#### CITY OF DARIEN

#### PLANNING, ZONING, AND ECONOMIC DEVELOPMENT COMMISSION

#### **AGENDA**

## AGENDA MEMO PLANNING, ZONING AND ECONOMIC DEVELOPMENT COMMISSION OCTOBER 15, 2025

SITE PLAN

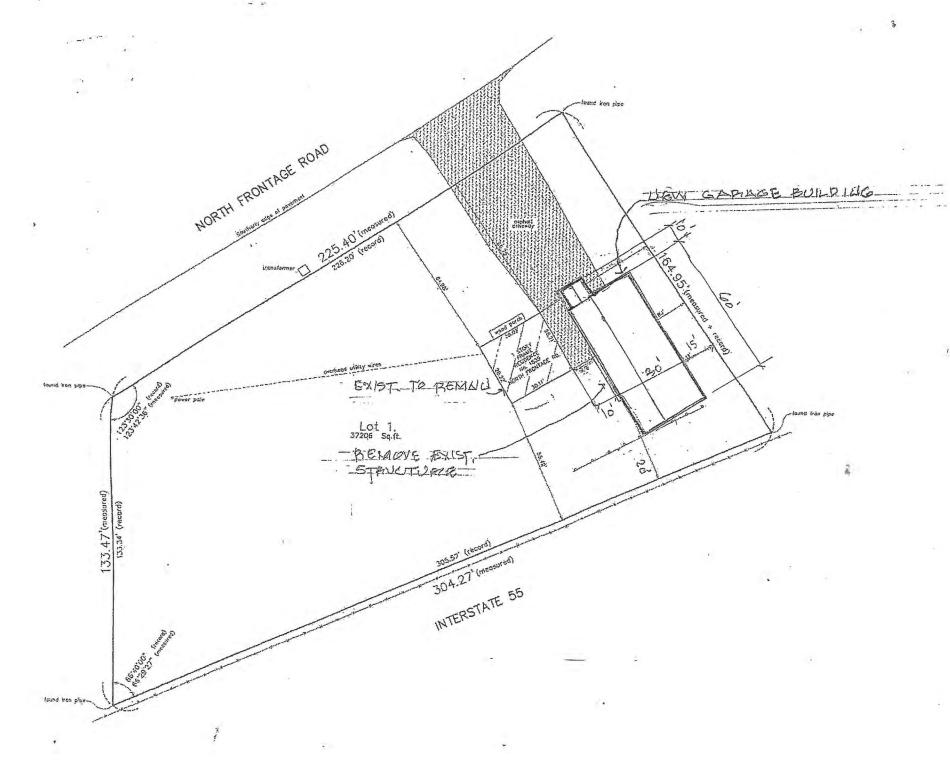
- 1. The proposed garage will replace an existing garage, and the net new impervious area will be less than 2500 SF, therefore no PCBMP stormwater requirements will apply.
- 2. We note that there is floodplain on the property, and that the proposed garage will be situated well outside of the floodplain.
- 3. Based on the Du Page County GIS topography, grading to create a level pad will likely be required to construct the garage as there are approximately three feet of fall across the footprint of the garage. A grading plan should be submitted.

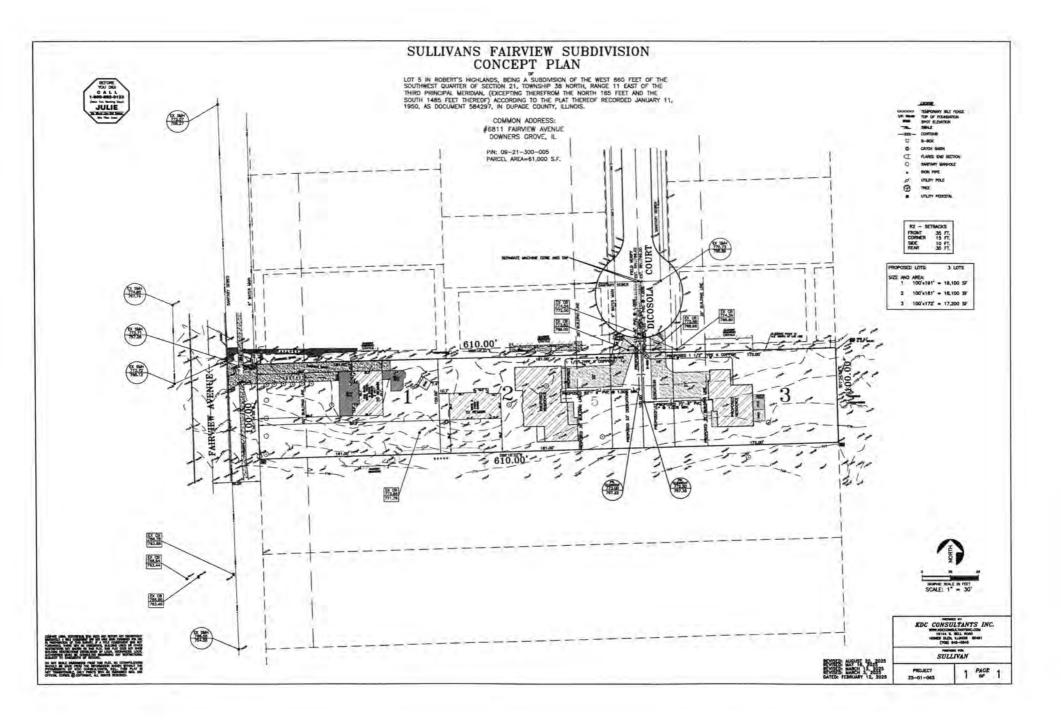
- 1. The proposed concept plan shows that the two new lots would have driveways extending to the existing cul de sac. When the Dicosola subdivision was approved, it was intended that the cul de sac would be temporary and set up for future extension to the south. That is evidenced by the temporary road easements and is stated in the approving ordinance (copy attached for reference). As such, the proposed subdivision should be required to extend the street and remove the existing cul de sac. City Code provides that the maximum cul de sac length shall be 500 feet, which would be achieved with the extension. Alternatively, consideration should be given to the potential for the street eventually being extended south then west to connect to Fairview Avenue.

- 5. The existing garage serving the existing house is show to remain, but on the new lot which will front Dicosola Court. This should be clarified.
- 6. An evaluation of net new impervious area should be included to determine what stormwater improvements will be required. This should include the street extension, and the new lots presuming maximum lot coverage.

- 7. Other items required by the subdivision code such as street trees, streetlights, easements, and cash donations will be evaluated at the time of final plat submittal.

**Existing Dicosola Court**

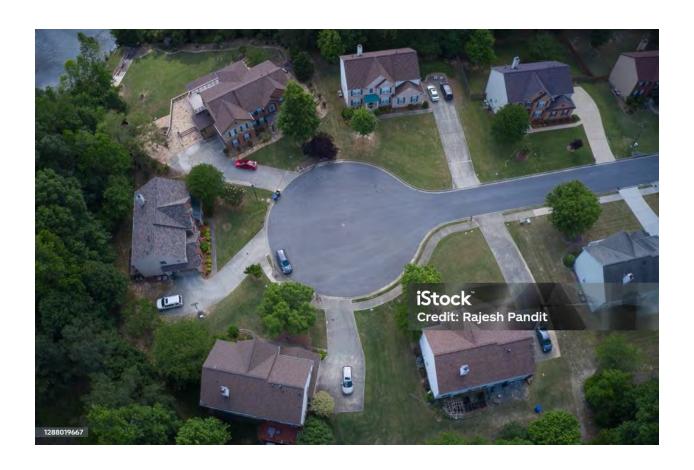
It is my understanding that Mr. Sullivan is proposing to divide his lot into three parcels with two of the parcels positioned off Dicosola Court and the third parcel remaining on Fairview Ave., however the two new homes planned for Dicosola Ct. will not face the court, like a typical culde-sac, but instead there will be two extended, L shape driveways built from the existing cul-de-sac leading to the two new homes positioned in line with the other homes on the court. I am not aware of any cul-de-sac in Darien designed in this manner. See **Exhibit A** for Mr. Sullivan's proposed layout. Typically, homes on cul-de-sacs face the court, so you see the home and not just a massive sea of concrete driveways. See **Exhibit B** – example of a typical cul-de-sac.

# Alternative Cul-de-Sac Design

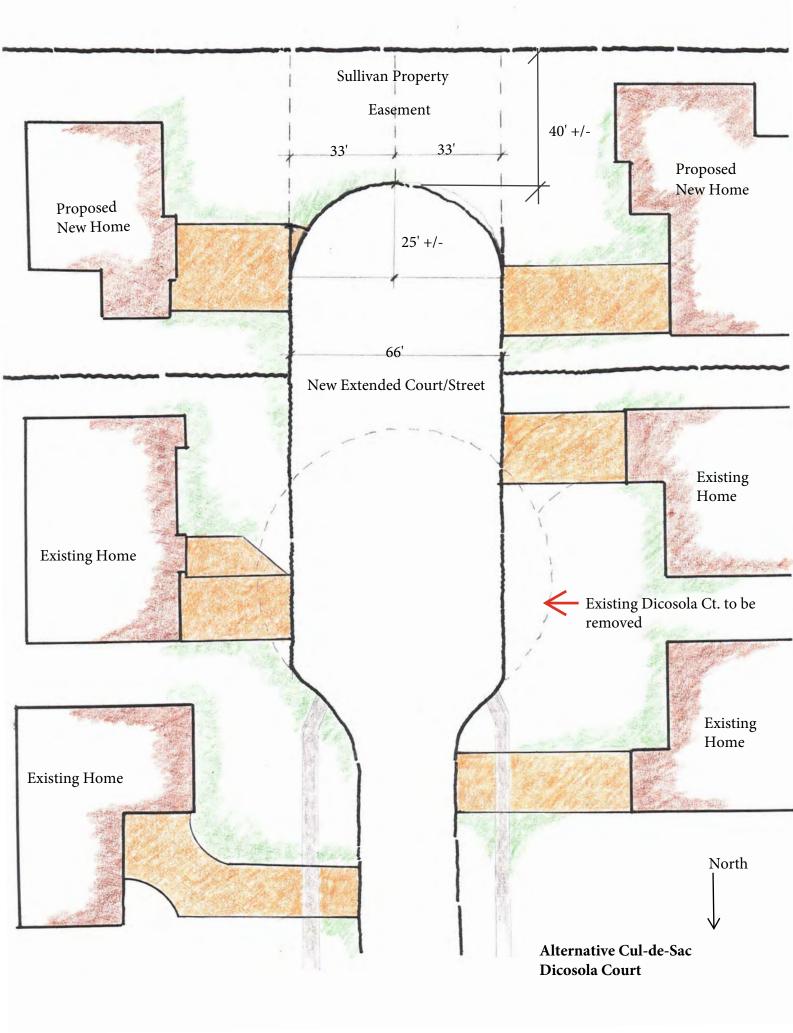
As I have stated, I believe the proper way to provide for this development of two additional single-family homes is to extend the street and reconstruct the cul-de-sac. Alternatively, looking at other cul-de-sac configurations in our general area, I discovered several in Hinsdale, which I believe might better suit our situation, if acceptable to Darien standards. The location of one of these is Thurlow Street which includes the addresses #940 and #941. Thurlow is one block west of Madison and north of 55<sup>th</sup> Street. It is an elongated rather than circular cul-de-sac, which allows for more street parking, less congestion, and easier snow removal. Attached is a drawing with rough dimensions, that shows how this could apply to our street. Note, at the end of the turn around the city would retain an area of right of way approximately 66' x 40'. This green space could resolve the issue of where to deposit plowed snow.
